Block Island Wind Farm CVA

Status of Verification of Substructure
Installation (July 19 to October 27)

October 27, 2015

Jacket 1 P1 cutoff Oct 8

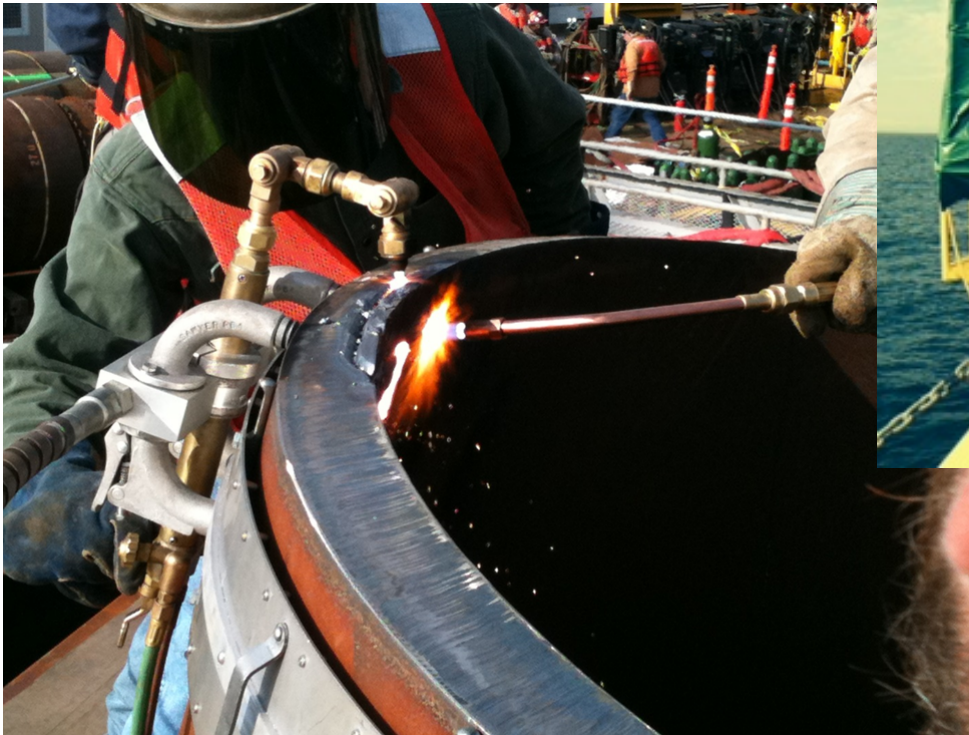
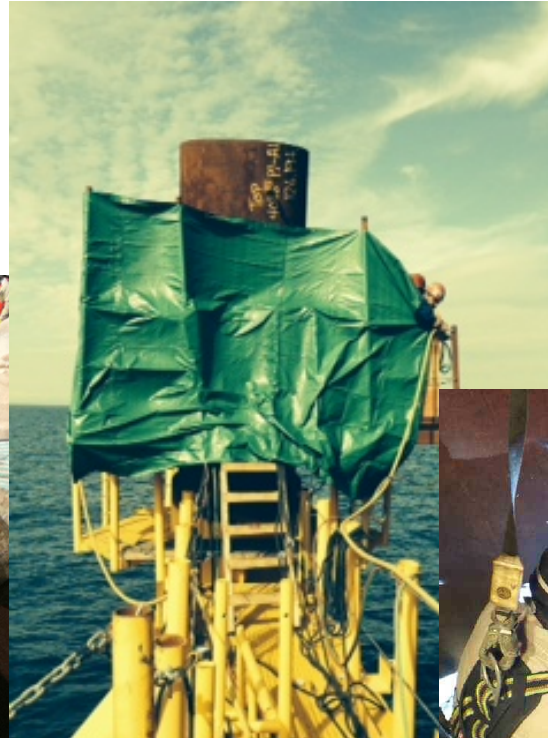
Jacket 1 P1 2 ½ in to 1 ¾ in
transition visible on cut off section
